St. Elmo Apartments: Site Plan 820170030

Staff Report Date: 5/5/2017

Site Plan No. 820170030

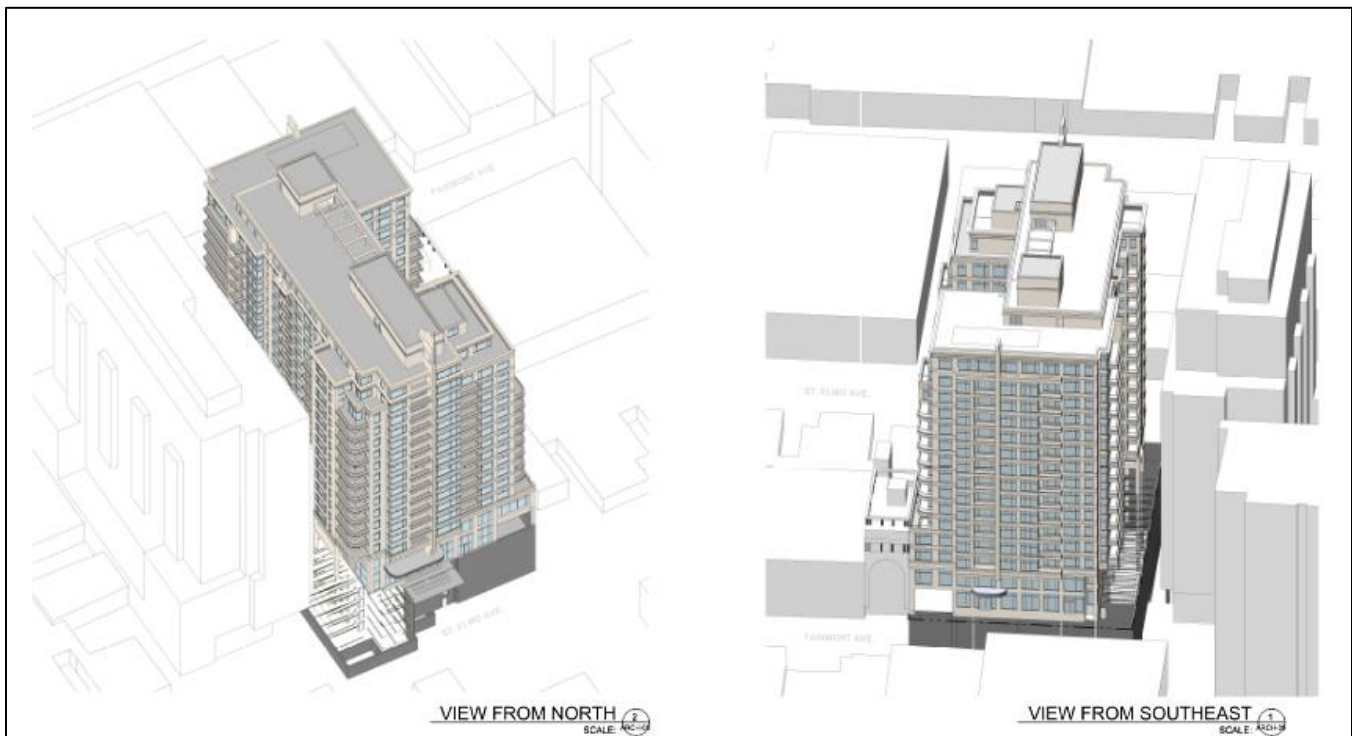
During review of the application, staff expressed concern at the narrowness of the separation between the proposed building and the adjacent Bainbridge Bethesda development along the through-block connection, which is illustrated at 23 feet at its narrowest. Staff recommended that the proposed building step back from the through-block connection to ensure sufficient sunlight and views to the sky. The applicant argued that since the issue was not raised during review of the sketch plan application, upon which they had developed their site plan design, it was no longer timely to make that recommendation. In discussions between the applicant, the Planning Director, and staff, it was agreed to allow the site plan design to remain as proposed. However, if the applicant redesigns the building to accommodate additional height afforded by the pending Sector Plan update, the staff recommendation for this site plan includes a condition that requires the entire site and building design to be in substantial conformance with the updated sector plan's design guidelines.
